# LSC Responses to EPC Deviation Redlines

**DEVIATION No. 1 – Intersection Spacing (Rev. 11/17/2023; 6/2/2023; Original 1/4/2020):** A deviation from the standards of or in Sections **2.2.5.D** and **2.3.2** of the Engineering Criteria Manual (ECM) is requested. The request is for – **Part 1a:** a full-movement, roundabout intersection on a proposed Non-Residential Collector street 580 feet south of the Woodmen Road/US Highway 24 intersection (centerline spacing – estimated, following widening of US Highway 24 to four lanes). **Part 1b:** a three-quarter-movement intersection (access to commercial lots- Willet Way) on a proposed Non-Residential Collector street 235 feet west of the Retail Row Street/Rio Lane intersection (centerline spacing).

Commons at Falcon Field (LSC# 234220)

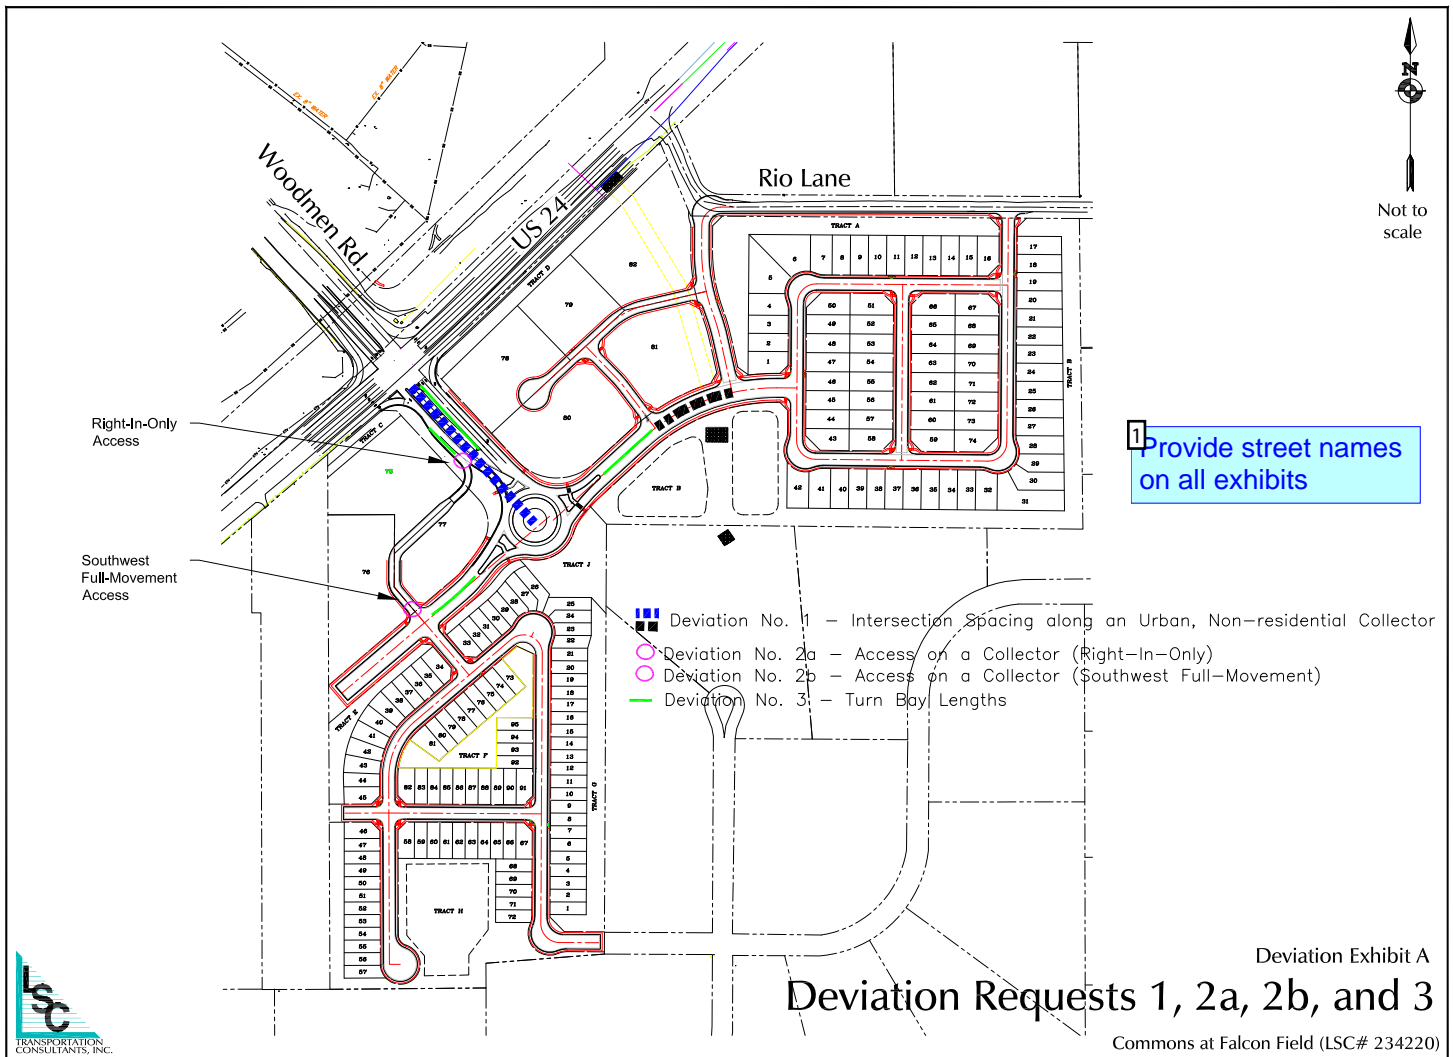
County approvals are conditional on CDOT approval. <sup>1</sup>

County approvals are conditional on CDOT approval.

Provide street names on all exhibits

👤 Author: jchodsdon Subject: Sticky Note Date: 2/4/2024 4:50:28 PM  
LSC Response: Added this note.

Author: jchodsdon    Subject: Sticky Note    Date: 2/9/2024 11:47:08 AM  
LSC Response: Added.

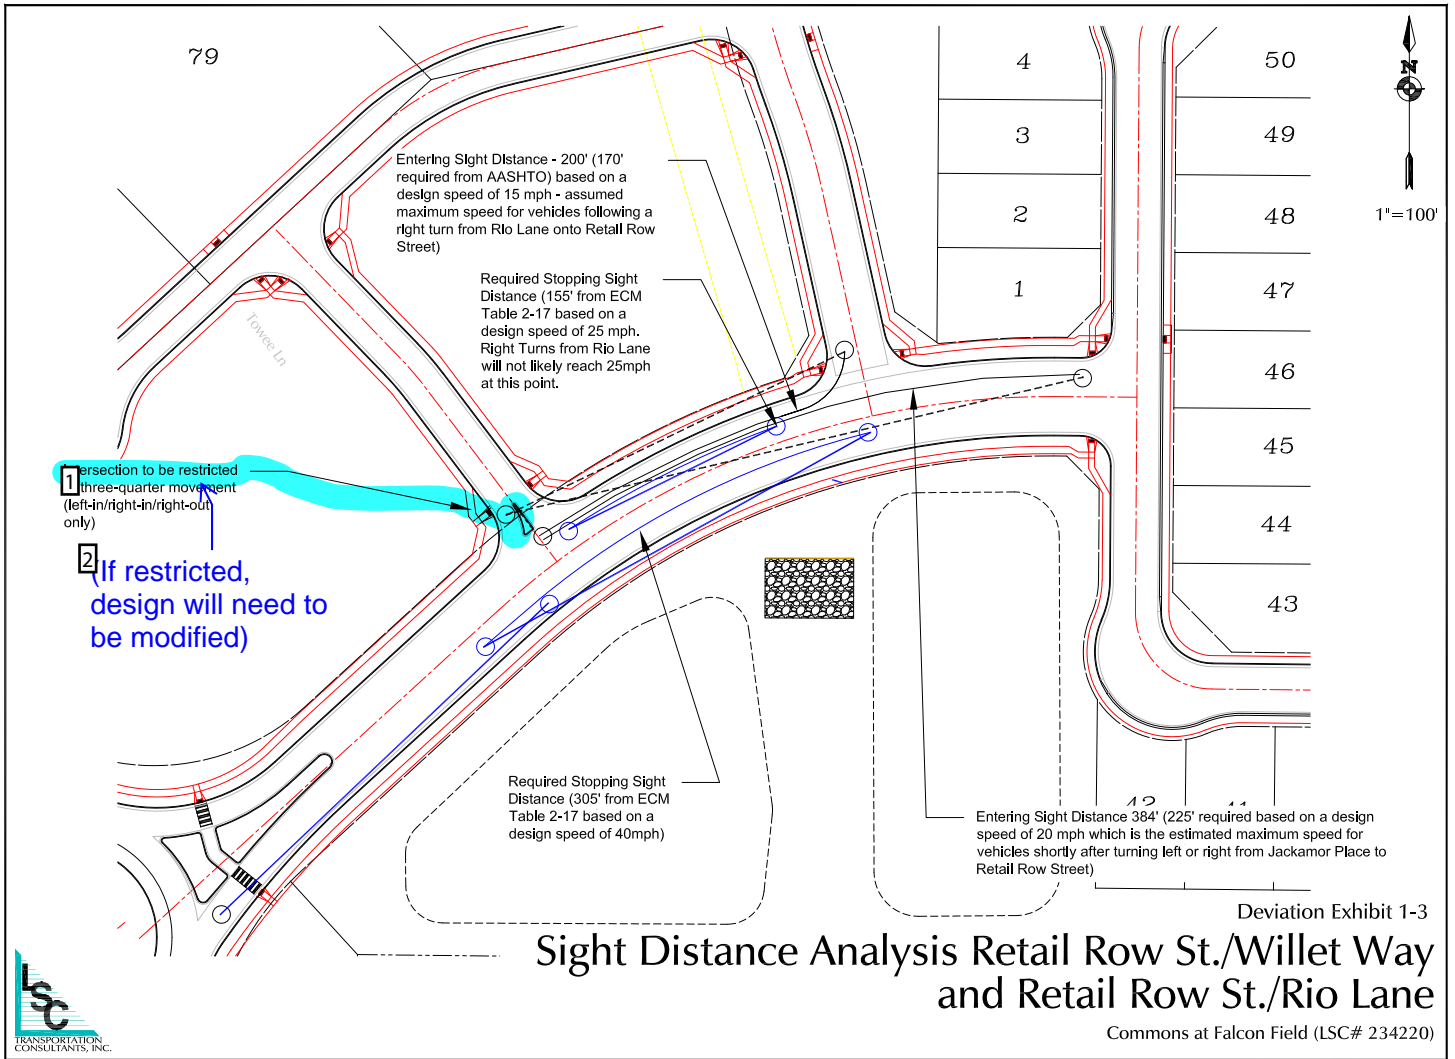
(If restricted, design will need to be modified)

LSC Response: This access has been modified to a full-movement and the right-turn island has been removed. Deviation No. 5 allows for this change.

Deviation Exhibit 2b-1  
Commons at Falcon Field (LSC# 234220)

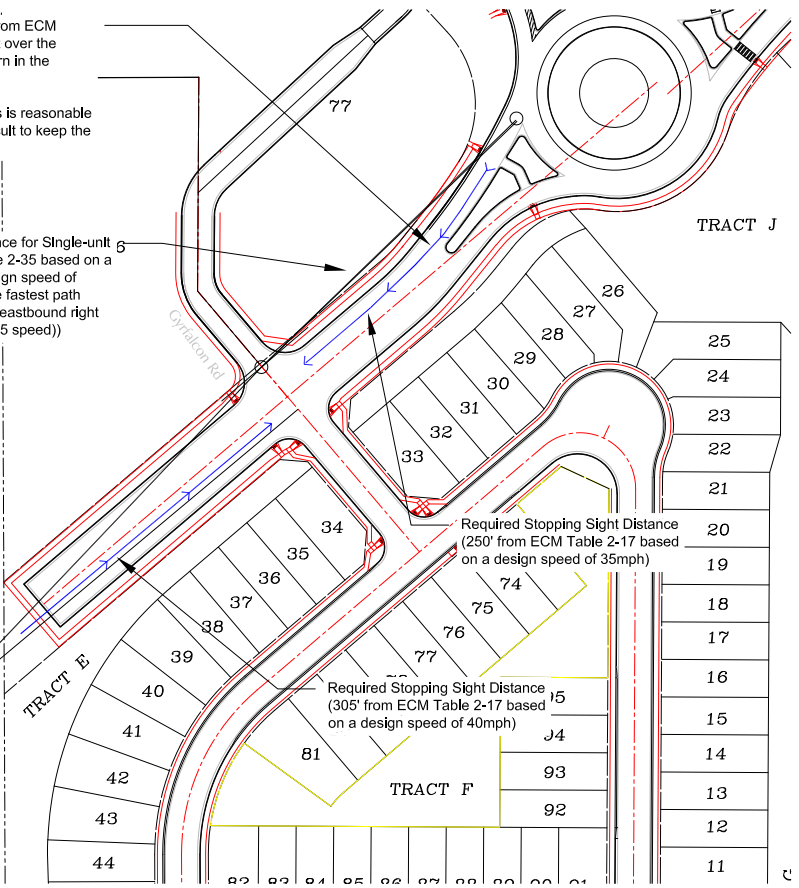
1 line is missing

[line is missing](#)

[/Nunbird](#)

Author: jchodsdon Subject: Sticky Note Date: 2/9/2024 11:48:47 AM  
LSC Response: Added. Figure Revised.

Author: jchodsdon Subject: Sticky Note Date: 2/9/2024 11:48:56 AM  
LSC Response: Corrected.

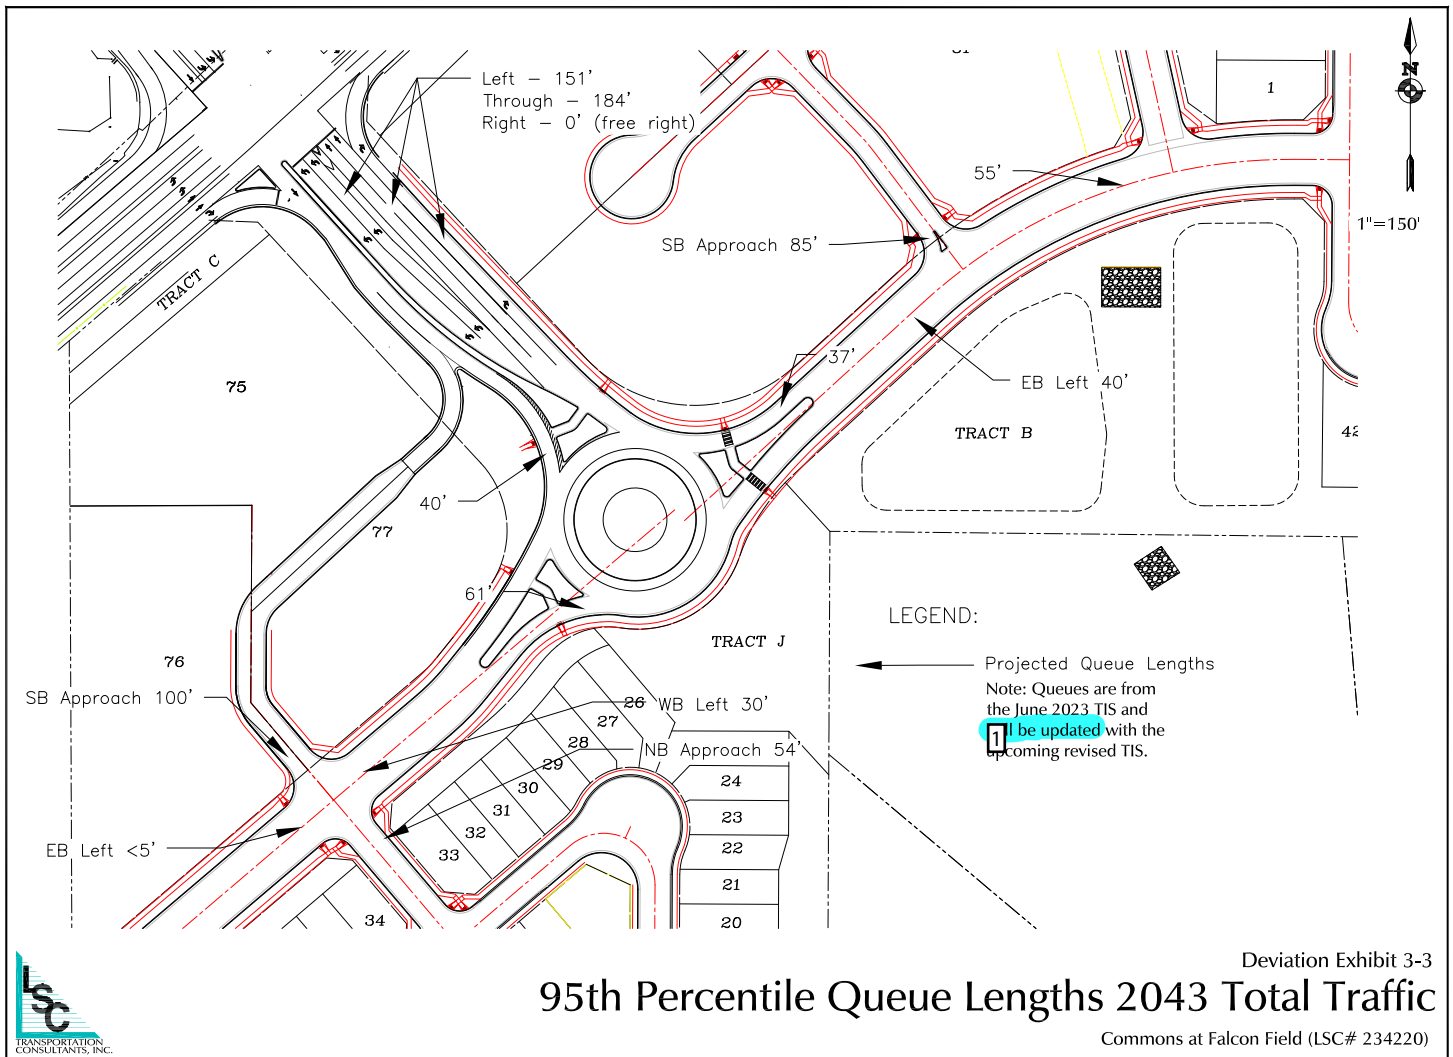
Number: 1      Author: Jeff Rice - EPC Engineering      Date: 12/19/2023 4:07:35 PM

Author: jchodsdon    Subject: Sticky Note    Date: 2/9/2024 11:50:33 AM  
LSC Response: This note has been removed.
